Project Name: Ocotillo Brine Reduction Facility Hydrochloric Acid Storage and Weak Acid Containment Mixing Improvements – Change Order No. 3
Project No.: WW2001.403
Rev. 1/16/2024

RE: Project No. WW2001.403 – Ocotillo Brine Reduction Facility HCL Storage and Weak Acid Containment Mixing Improvements – Potential Change Order 009 – DC 005 Pump Hydraulic Solution

Title:	Pump Hydraulic Solution – Lowering Pumps	No.:	005
Request Date:	2/4/2025		
Project:	Ocotillo Brine Reduction Facility HCL Storage and Weak Acid Containment Mixing Improvements		
Contractor:	Garney Construction		
Contract No.:	WW2001.403

A2 EXISTING SUCTION/DISCHARGE PIPING
NOT TO SCALE

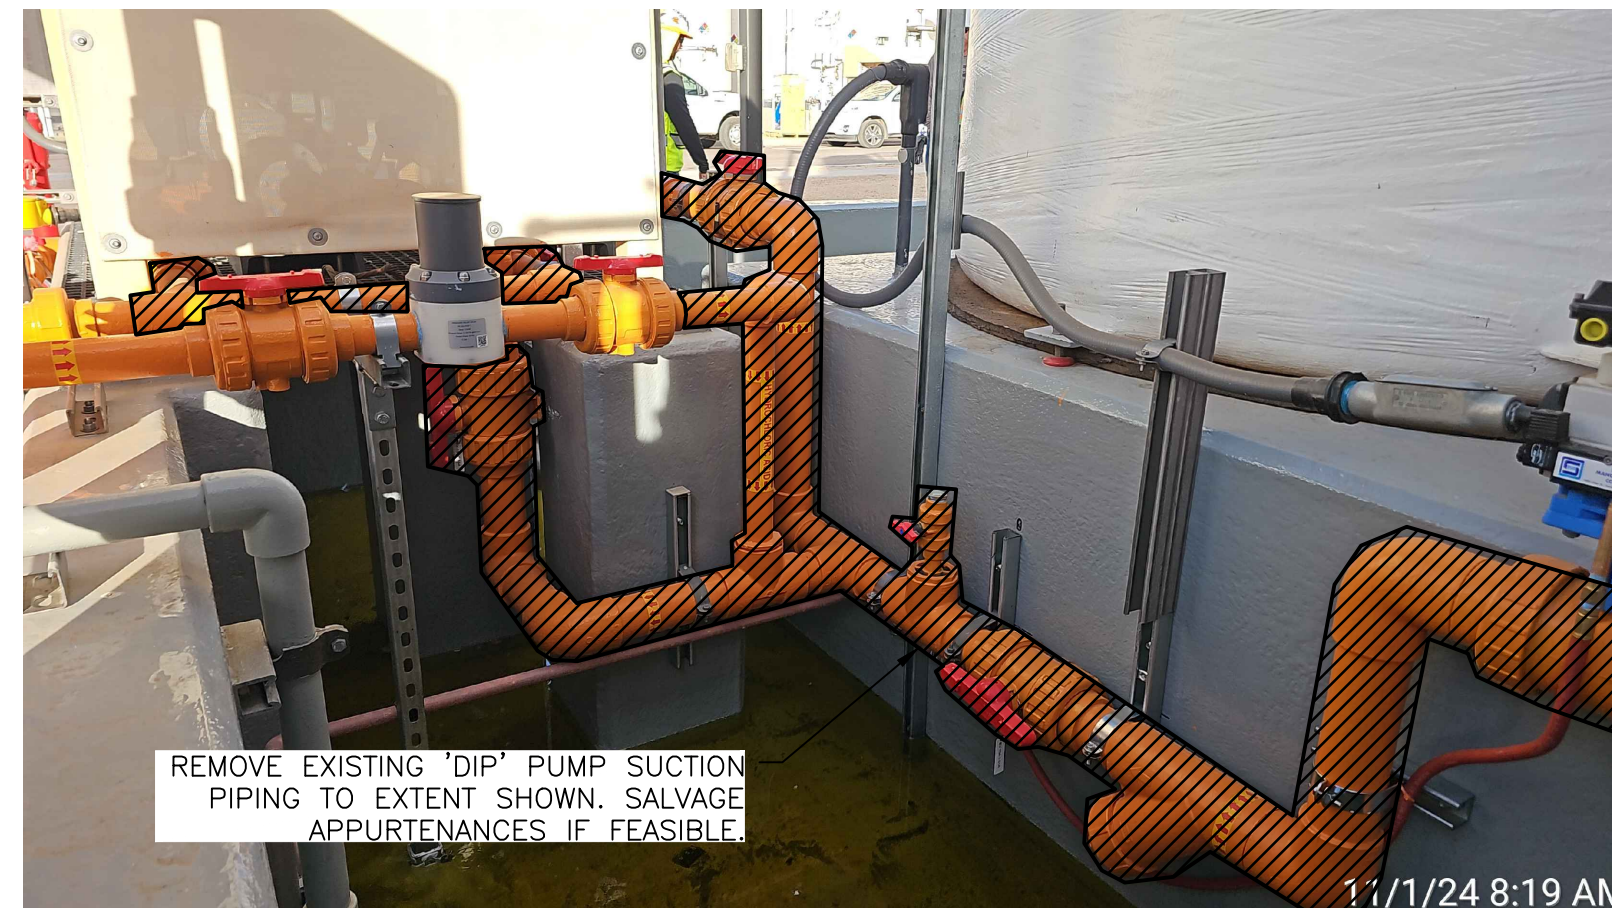
The transfer pumps at the 5,000-gal HCl tank shall be lowered and the pump suction piping modified as shown in the attached drawings. The modifications include the following:

- Pump suction elevation should be equal to or lower than the elevation of the tank outlet penetration.
- Pump suction piping should be reconfigured to slope from the tank outlet down to the pump suction connection.

- Modify/replace pump suction piping. Existing pneumatic shall be salvaged and reused; manual isolation valves shall be reused where possible.
- Cut/trim existing concrete pedestal below pump skid to allow for lowering of pump skid
- Modify pump skid FRP grating and FRP mounting bracket system to be attached to the containment well at a lower elevation
- Reinstall pumps, including alignment and startup by pump manufacturer's representative per specifications
- Modify discharge piping to match new pump elevation.
- Coating of new piping, valves, and fittings; coating of concrete column
